HISTORIC AND DESIGN REVIEW COMMISSION

HDRC CASE NO: 2019-082
ADDRESS: 931 HAYS ST
LEGAL DESCRIPTION: NCB 1654 BLK B LOT S 140 FT OF 16
ZONING: R-5, H
CITY COUNCIL DIST.: 2
DISTRICT: Dignowity Hill Historic District
APPLICANT: Adam Sanchez
OWNER: Adam Sanchez, Adam Sanchez
TYPE OF WORK: Construction of 2-story residential structure
APPLICATION RECEIVED: February 14, 2019
60-DAY REVIEW: April 15, 2019
REQUEST:

The applicant is requesting conceptual approval to construct a new, 2-story residential structure on the vacant lot at 931 Hays, located within the Dignowity Hill Historic District.

FLOOR PLANS

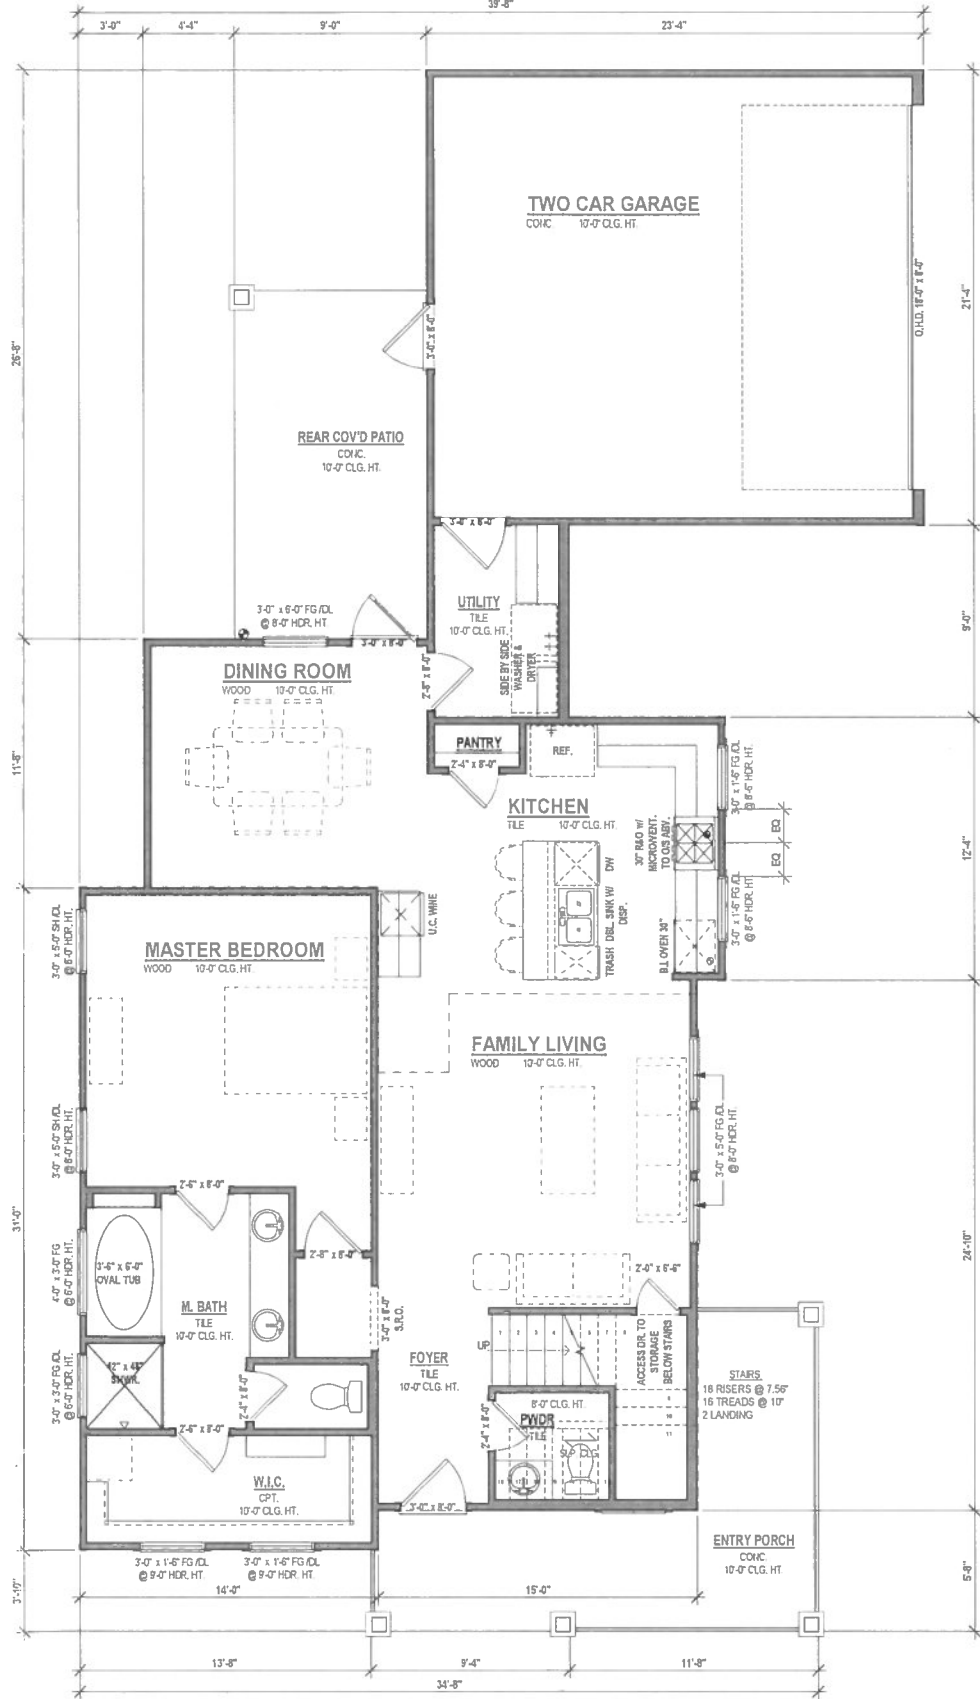
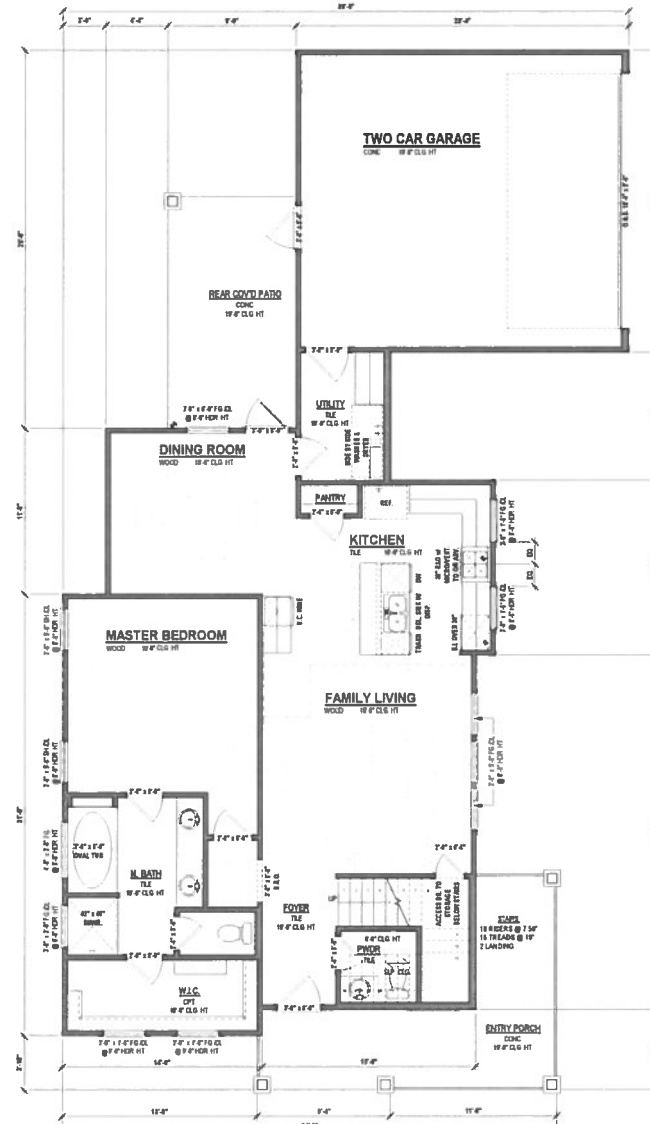
- o. ARCHITECTURAL DETAILS (GARAGE) – The applicant has proposed an attached garage with parking for two automobiles. Garages, when found historically within the district are detached from primary historic structures. Staff finds that the proposed garage should be detached from the historic structure. Additionally, the proposed garage structure should feature separate garage doors. Garage doors should be wood or metal.

- vii. That the proposed garage be detached front the primary structure and feature two garage doors and two garage door bays.
- viii. That the proposed driveway does not feature more than ten (10) feet of continuous paving.

CONCEPTUAL ELEVATION A

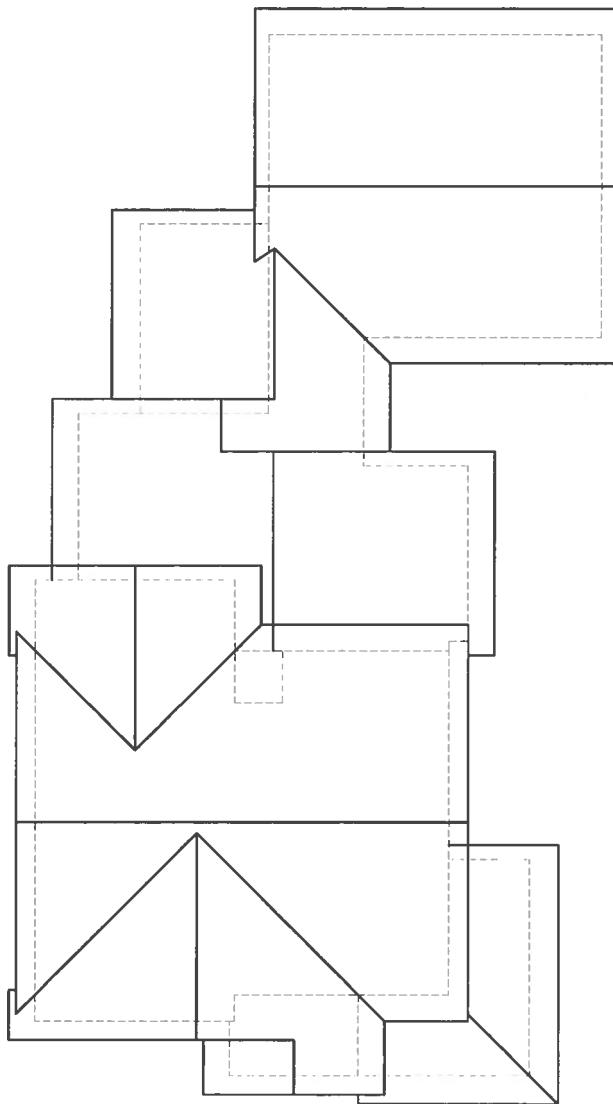
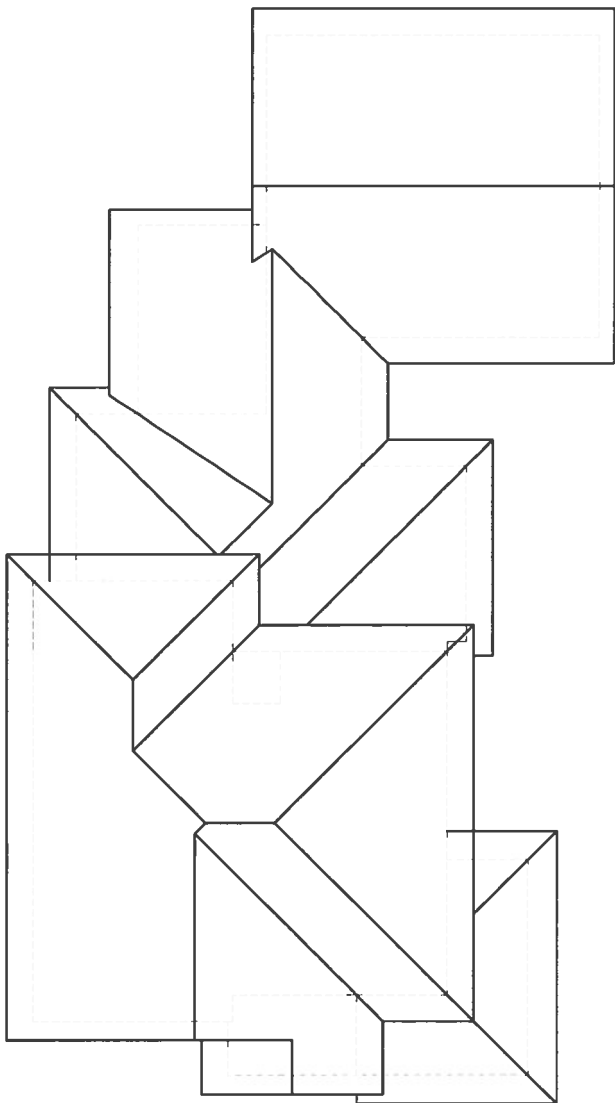
- i. ROOF FORM – The applicant has noted two options for the proposed roof form; a side gabled roof and a hipped roof. Staff finds the hipped roof to be more appropriate due to its reduced massing.

- iv. That the applicant utilize a hipped roof to reduce the perceived massing of the proposed new construction.
- v. That the proposed horizontal Hardie siding should feature an exposure of four (4) inches and a smooth finish and that the proposed board and batten siding should feature boards that are no wider than twelve (12) inches wide and battens that are no wider than 1 – ½” inches wide. The incorporation of window shutters may be appropriate if they are functional and installed in a traditional manner.
